Re: Conditional Use Time Extension Request for the Red Rock Brewery Brewhouse –
PLNPCM2018-01088

Re: **PLNPCM2018-01008 and PLNPCM2019-00255** Conditional Use and Conditional Building and Site Design Review for the Red Rock Brewhouse – Brewery and Tasting Room

RED ROCK BREWING CO. BREWHOUSE III

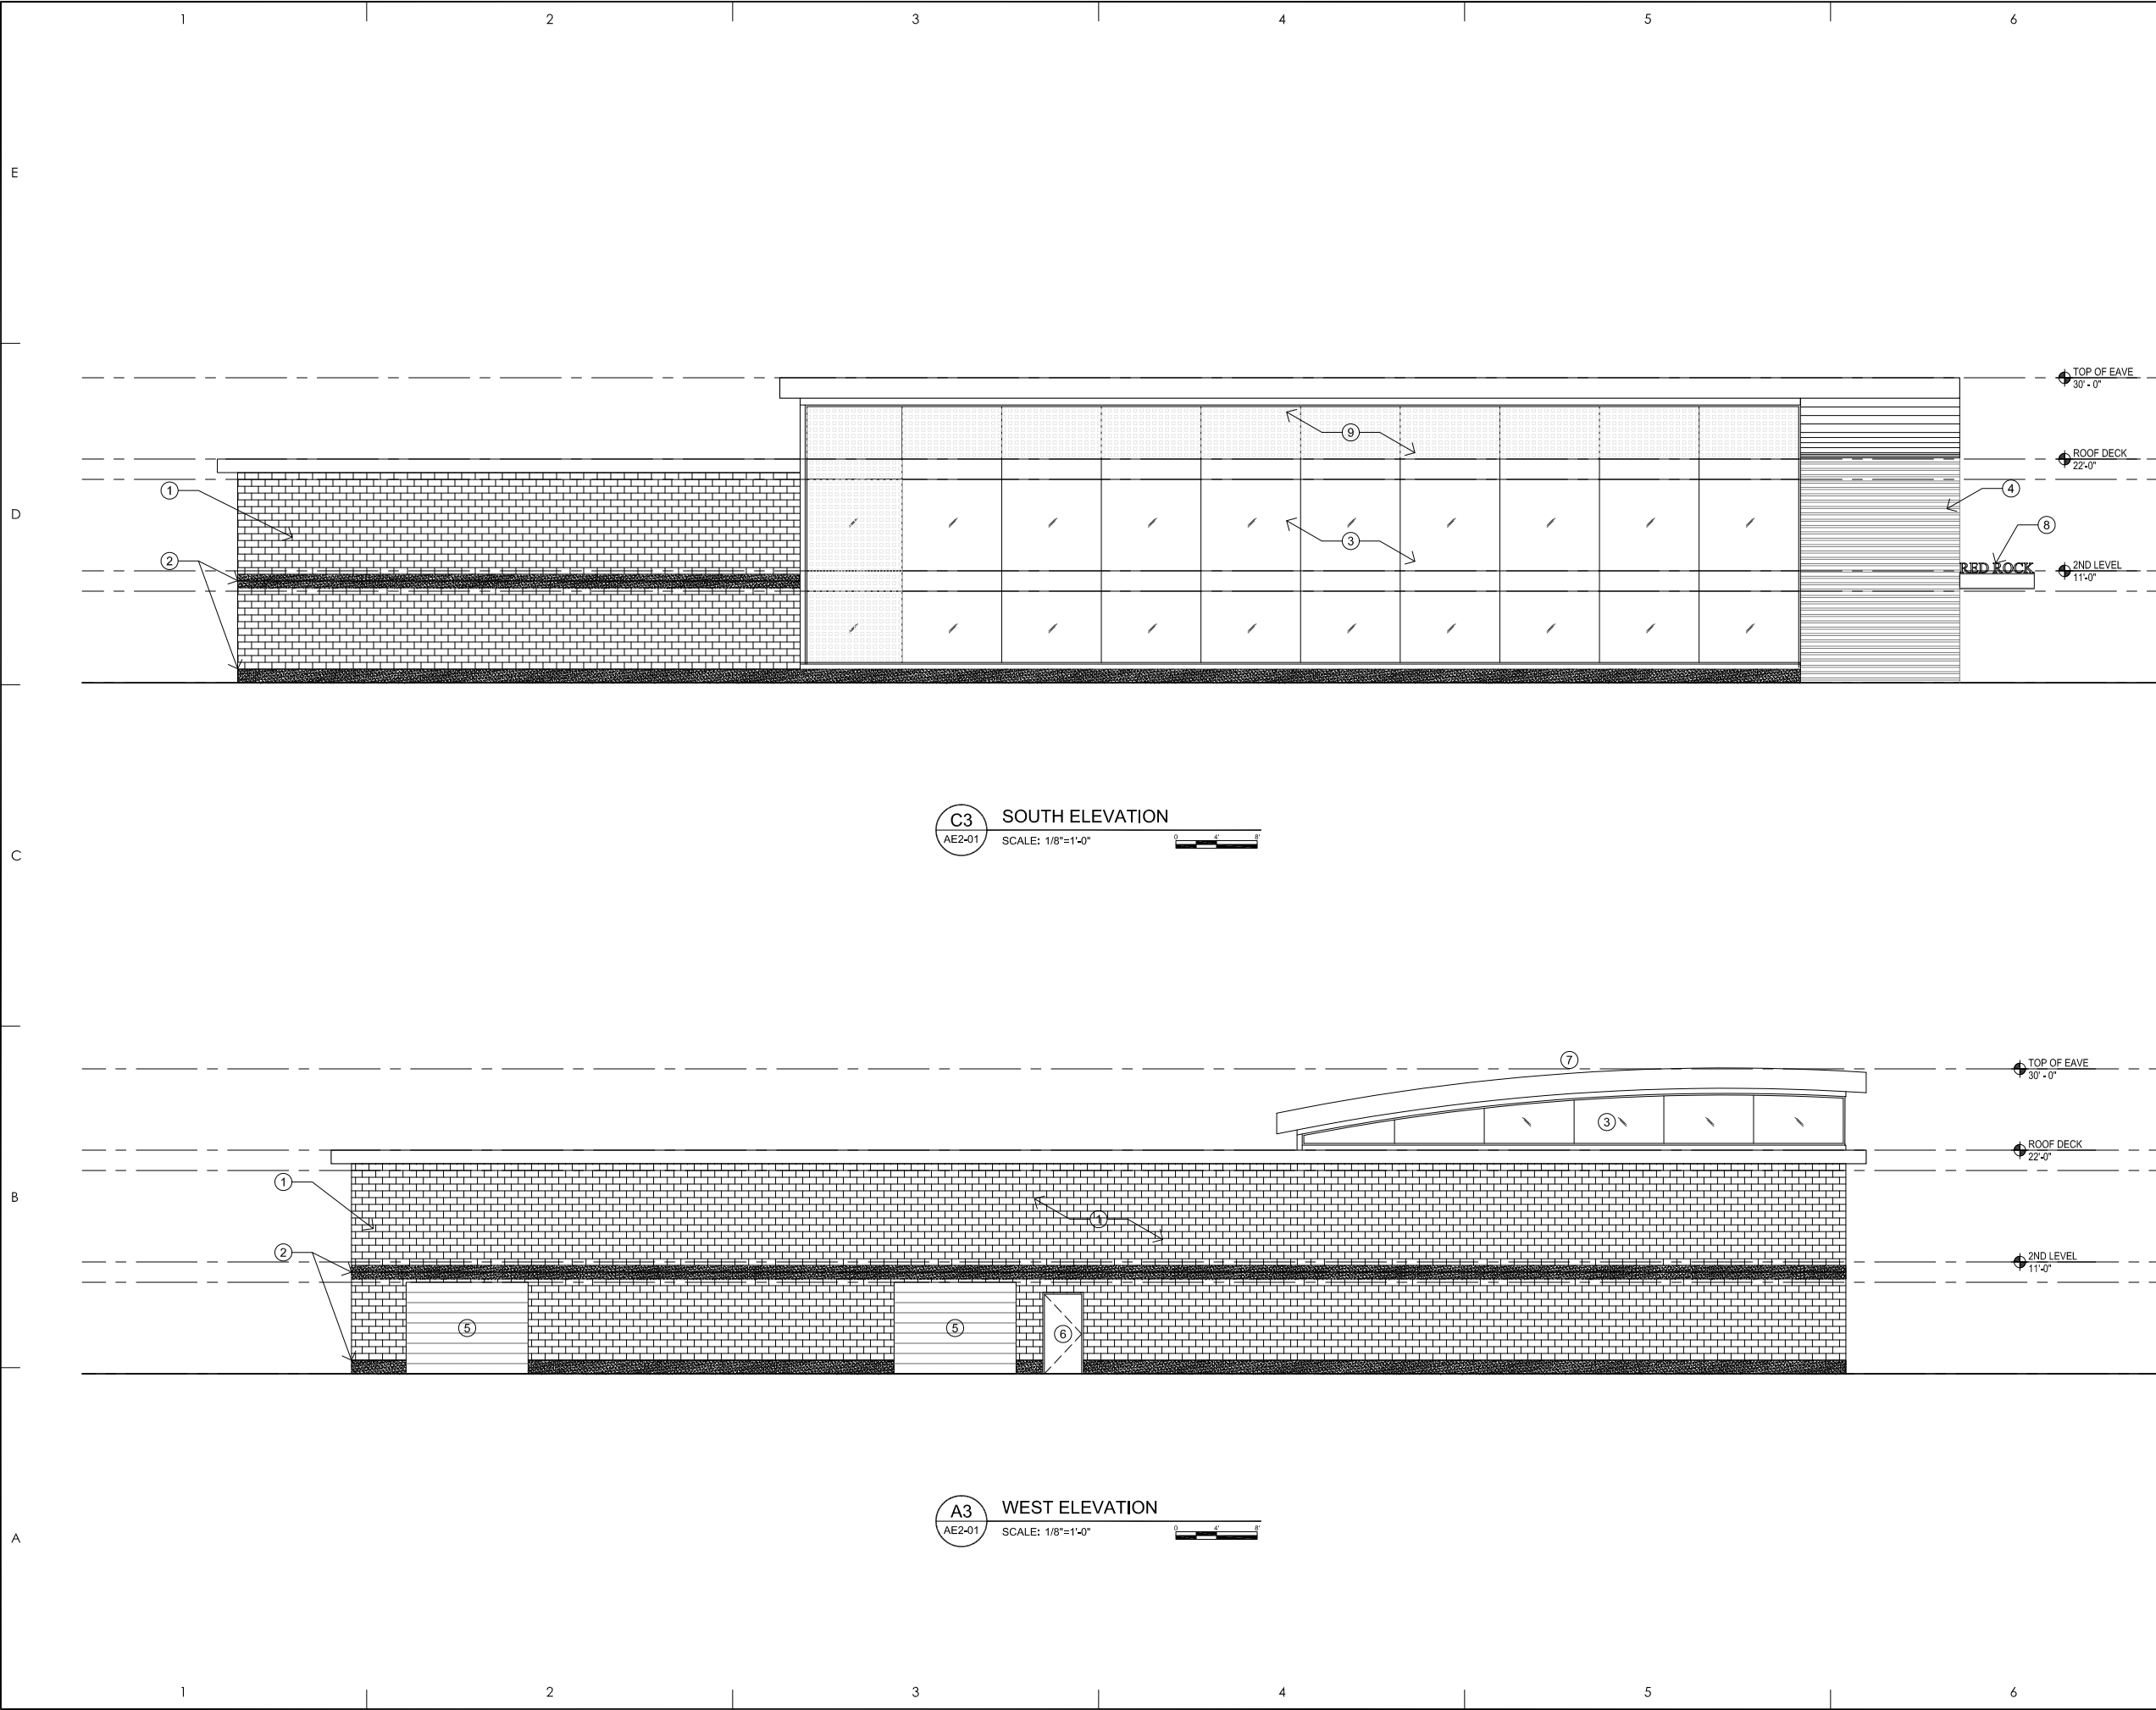
standard is to provide active building frontages that add interest, life, and vitality to the public realm. On the south and east facing street level façades, the proposed design incorporates walls that exceed that length. The south elevation includes a section of blank wall that measures approximately 55-feet 4-inches in length and the east elevation includes a blank wall section that is approximately 21-feet in length. The applicant has stated that this is a response to the internal functions and programming of the building. The addition of extra glass on the south elevation is intended to partly offset this. As outlined in consideration 2 above, they are proposing to incorporate approximately 1411 square feet of glass on the south elevation which is well in excess of the required 508 square feet. The location of this however is part of the CBSDR modifications requested. The applicant's narrative also describes the material changes in terms of the brewery and brewery support functions and that additional windows may be added to the second level as offices once the building programming has been finalized. The blank wall and glass requirements pertain to the ground floor level so the addition of glass to the second floor level is not germane to meeting the regulations and cannot be guaranteed by Planning Staff nor is it something that would meet the Design Standards.

Planning Staff acknowledges the programming needs of the building as a consideration in regard to the requested modification to allow for larger blank wall spaces on the south elevation but has concerns about how this elevation will impact the pedestrian experience and street interaction due to the lack of detailing on the south facade. Planning Staff is recommending that the Planning Commission approve this modification to allow for a longer blank wall but require that the applicant integrate some kind of artwork, mural or other element of visual interest along that elevation in order to break up the blank wall space. Staff is including this as a condition of approval.

1. *Artwork, a mural or other element of visual interest along the south elevation is required in order to break up the blank wall space and provide the appearance of activity.*
2. *One additional doorway must be located along the south elevation in order to break up the blank wall space.*
3. *Final approval of landscaping, signage, lighting and the visual addition on the south façade is delegated to Planning Staff to ensure compliance with applicable standards.*
4. *Any modifications to the approved plans after the issuance of a building permit must be specifically requested by the applicant and approved by the Planning Division prior to execution.*
5. *Applicant shall comply with all other department/division requirements.*

South Elevation Required per 21A.37.060

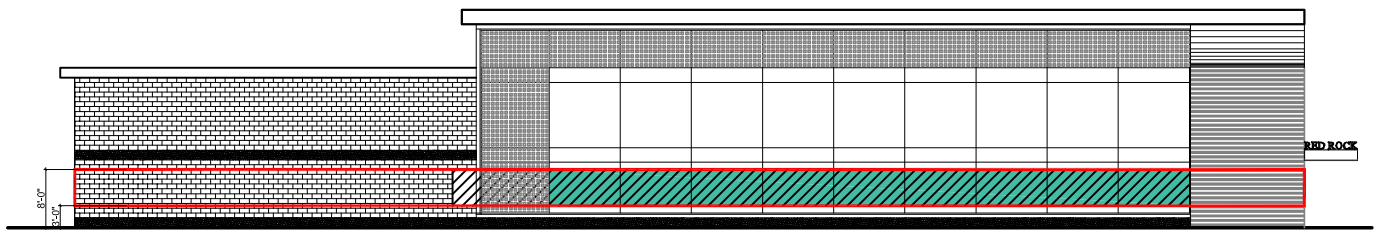
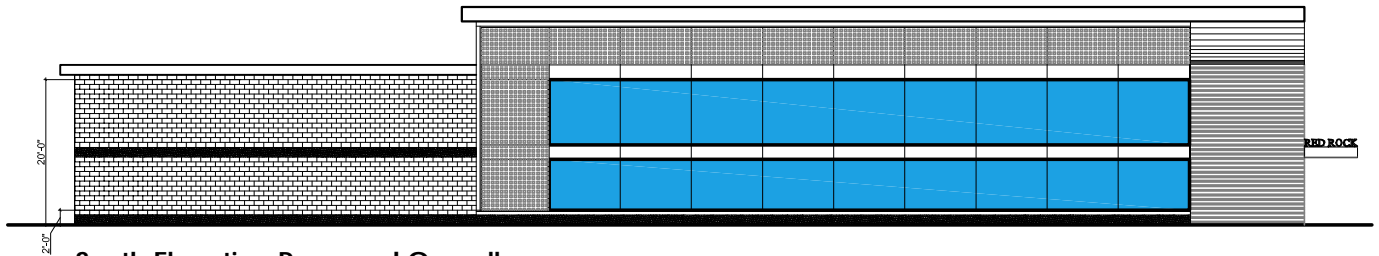
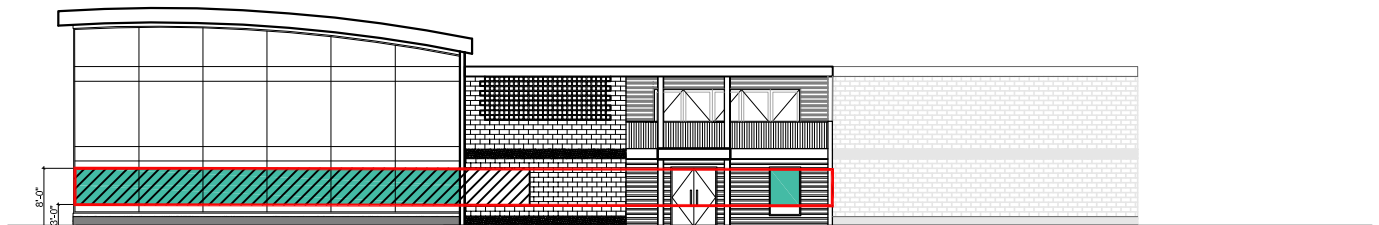
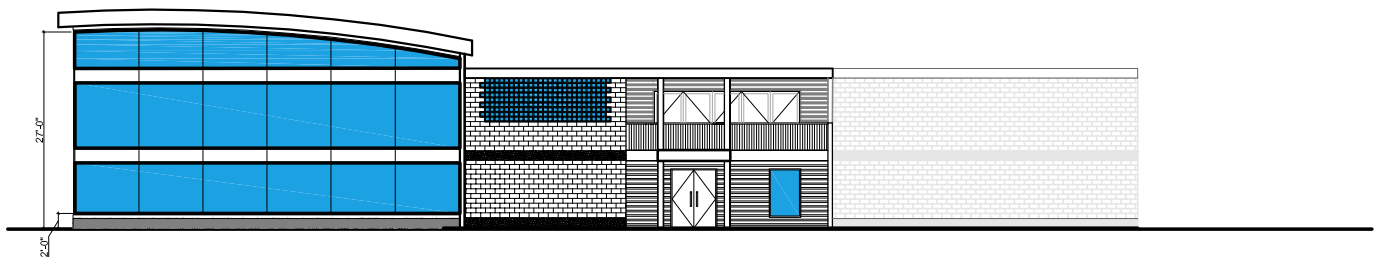
The ground floor glass requirements per Chapter 21A.37 – Design Standards specify that the street-facing facades must incorporate 60% glass in the area from three (3) to five (5) feet above grade. On the south-facing elevation toward 400 North, this would equate to approximately 508 square feet of glass being required within that zone. The applicant's design concentrates the glass on the east side of the south façade, in between two (2) and twenty (20) feet above grade. As a result, they are proposing to provide approximately 1411 square feet of total glass area on that elevation, but only 441 square feet within the required 2 to 8 foot area above ground level.

On the east-facing elevation toward 400 W, the required glass between 3 and 8 feet is approximately 313 square feet. The applicant has proposed to incorporate a total of 1100 square feet of glass on that elevation, but only 285 square feet within the required area. The provided glass would be located between 2 and 27 feet above grade and is concentrated toward the south side and the corner of 400 N and 400 W. The requirements specify between 3 and 8 feet but the design put forth by the applicant extends lower (to 2 feet) and much higher (27 feet) above grade.

Planning Staff is recommending that the Planning Commission approve this modification to the glass requirements as the development is exceeding the overall area of glass required and using it to create a pedestrian focal point toward the corner of the building.
